Orsted Onshore Ireland Midco Limited

10: MEMORANDUM RESPONSE TO SUBMISSIONS RECEIVED

LANDSCAPE AND VISUAL AMENITY

Proposed Oatfield Wind Farm Project, Co. Clare: ABP
Case No. ABP-318782-24

Figure 3.2: Zone of theoretic visibility map (based on a bare ground scenario) from the Sunyata Buddhist Retreat

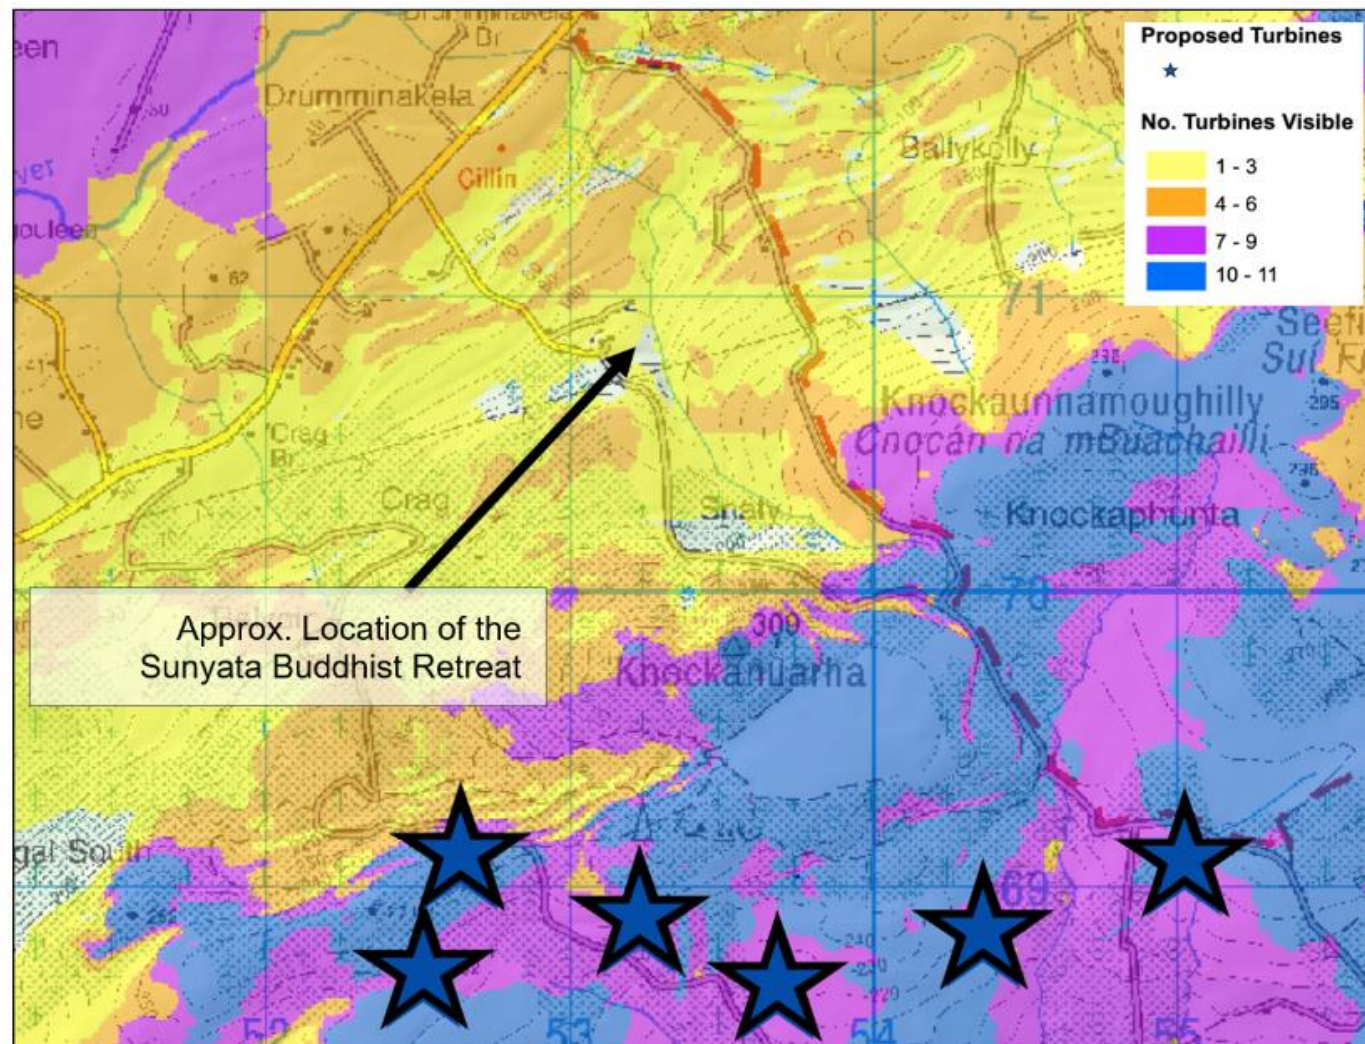
3.7.6 Sunyata Buddhist Retreat:

With regard to the Sunyata Buddhist Retreat, this is located on private lands and would not typically be identified as a publicly accessible receptor for LVIA. As per the Notes and Clarifications on aspects of the 3rd Edition GLVIA, it states, "*A LVIA should consider views from local communities focusing on the way that a community currently experiences views from public locations such as streets and open spaces and how those will change.*" It is also important that despite the near distance of the Sunyata Buddhist Retreat to the Proposed Development (c. 1.7km north of the nearest turbine), it has a very limited potential for clear visibility of the Proposed Development due to the intervening terrain located to its south. Indeed, and as per the bare-ground ZTV (

Figure 3.2), the landscape in the immediate surrounds of the Sunyata Buddhist Retreat has the theoretical potential for between 1-3 turbines, and in some localised areas, there is no potential for turbine visibility at all. A further analysis using wireframe views from this location identified that there is very limited potential for clear visibility of the turbines from this landscape context (refer to Appendix 1). In fact, once screening in the form of existing surrounding vegetation is accounted for, the proposed turbines will largely be screened from this viewing context, and the residual visual effect is deemed no greater than Slight-imperceptible.

Figure 3.3: Turbine ‘scale in relation to distance’ relationship

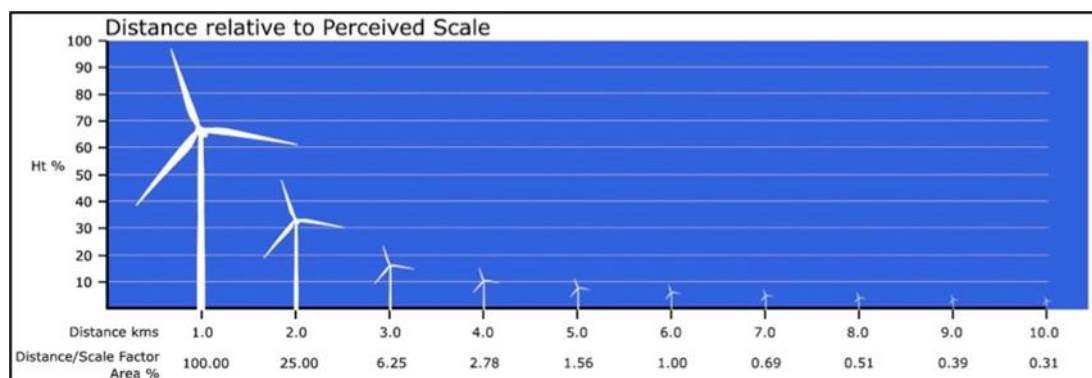
"The applicant has not introduced any mitigation measures such as landscaping, screening turbines to blend with the surroundings."

It is not common practice to try to screen turbines with areas of planting. Proposing planting within and surrounding the proposed array will have little to no effect on the perceived scale of the Proposed Development from the nearest surrounding receptors. Instead, compliance with the current visual amenity offsets outlined in the WEDGs (2019 revision) is considered a more effective best practice. For the Proposed Development, the minimum distance of any turbine from the nearest residential receptor is 725m, which is in excess of the draft Wind Energy Development Guidelines (2019) minimum set back of 500m and greater than the setback distance of 4 times the tip height of the proposed turbines. In this instance the setback distance for visual amenity purposes would be 720m from residential receptors on the basis of the 180m high turbines (this represents the greatest potential setback distance with regard to all potential turbines ranges).

Variation in residential buffer distances within the nearest kilometre has a much more noticeable effect on perceived turbine scale than when it occurs in the context of more distant views. This is due to the law of perspective – that doubling the distance to an object halves its perceived height. The reduction factor is even more pronounced when considered in the context of the ‘swept area’ of a turbine’s blades and not just in its tip height. This exponential ‘scale in relation to distance’ scenario is illustrated below.

Figure 3.4: Scenic routes in County Clare in relation to the Proposed Development and selected viewpoints overlaid with the zone of theoretic visibility pattern

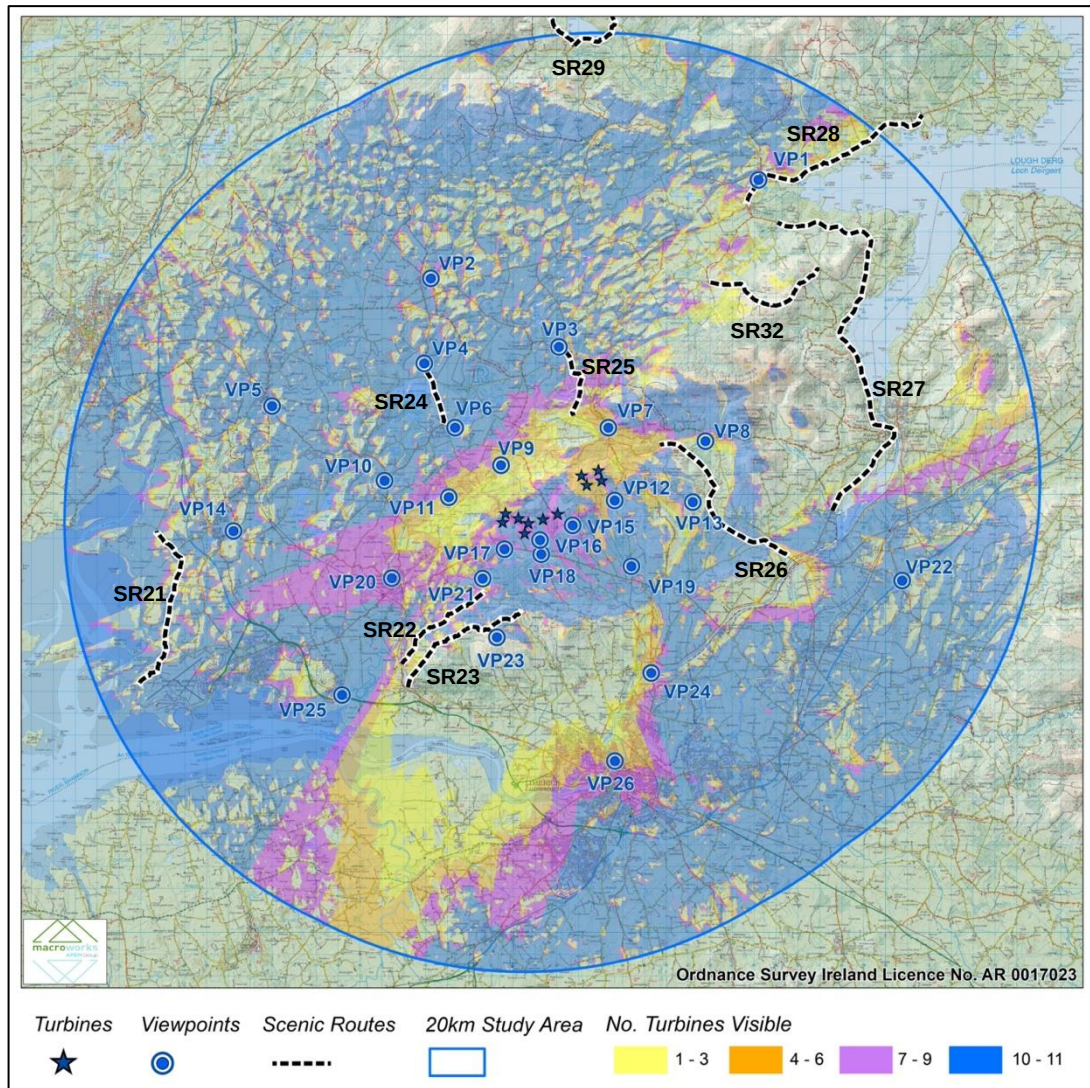
"Photomontages have been set up in a misleading manner. Viewpoints are selected in which bushes block the most overbearing of visual impacts, leading to what seems a lesser impact than is the case. This is intentionally cunning, and not in the spirit of a fair planning process."

Whilst it is noted that there were minor errata in the referencing on Table 14.6 of the submitted **EIAR Chapter 14**, it is important to note that all scenic routes within the study area have been assessed as part of the LVIA. Macro Works have a fully digitised data set of all scenic routes within County Clare, all of which were visited and driven during fieldwork investigations. Whilst the reference of some of these is incorrect in Table 14.6, each of these designations where there was potential for theoretic visibility (refer to Figure 3.4) was assessed for actual turbine visibility during fieldwork investigations. All scenic routes with potential visibility of the Proposed Development were included as viewpoints for assessment as highlighted on Figure 3.4 below. In instances, where scenic routes are heavily screened from the Proposed Development by surrounding terrain and vegetation, a view was selected from the clearest section of the route, or the nearest representative location to it.

As noted in Section 14.8.3.6 of **EIAR Chapter 14**, the residual significance of visual effect at viewpoints representing scenic designations within the study area (VP1, VP3, VP4, VP22, VP23) ranged between Moderate-slight and Slight-imperceptible. Thus, it is not considered that the Proposed Development will result in significant visual impacts in respect of scenic designations within the Study Area.
